Waddow View

Clitheroe.

Design Justification Statement

December 2018

AMENDED LAYOUT - Rev P6 DATED 12-12-18

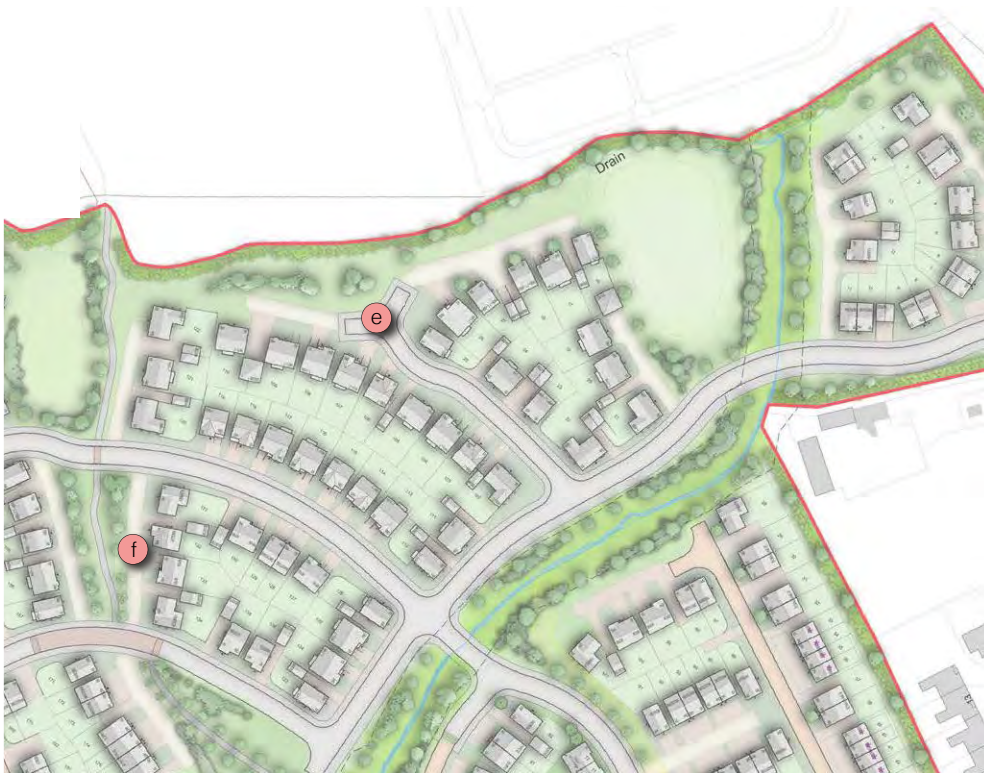
- a) Reconfiguration of the private drive to be more swept and traditional in layout.
- b) Removal upfront parking to the street scene to the gateway to the site.
- c) Removal of driveway that 'cuts' into the public open space.
